# Technical Service Bulletin

**Cobra Moto, LLC**

## 2017 P3 Shock Absorber TSB1617

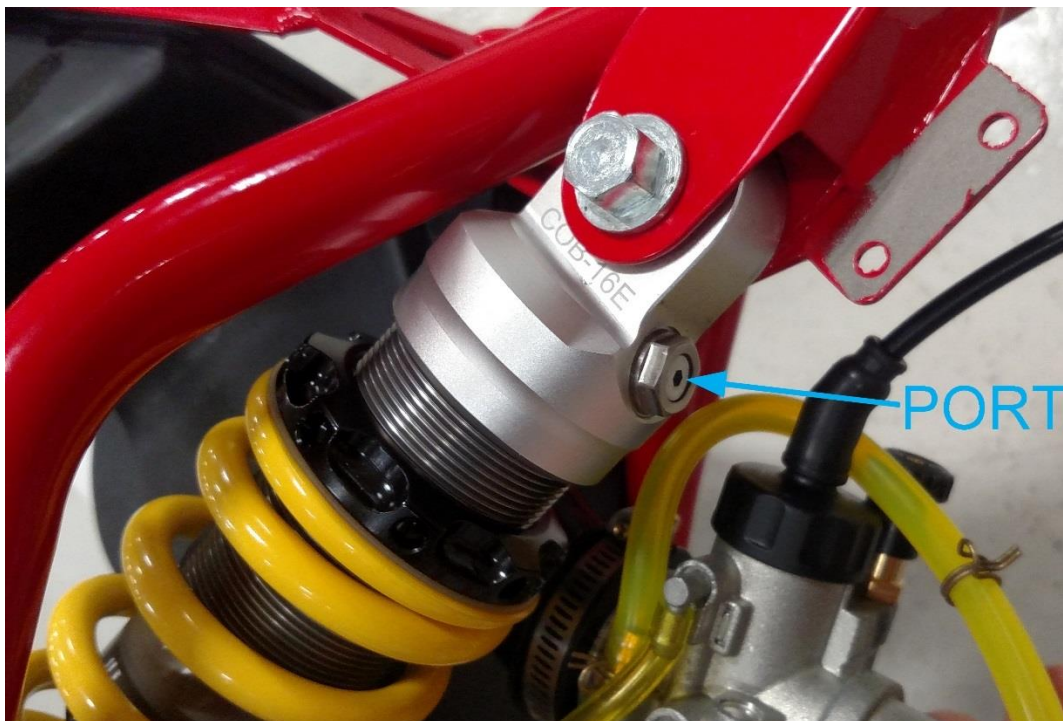
2017 CX50 P3 with VIN up through CP35017071 have shock absorbers that could contact the frame in extreme bottoming conditions.

Customers are asked to send their shock back to Cobra for a minor geometry change to the shock body cap.

Upon receiving their shock back, customers will mount the shock onto the bike in a different orientation. New mounting orientation (after the modification to the shock body cap) is show below. This new orientation has the shock body cap in the upper mount with the pressure access port visible toward the engine

Do not mount your shock in this orientation without first getting the modification done to the shock body cap or damage will occur.
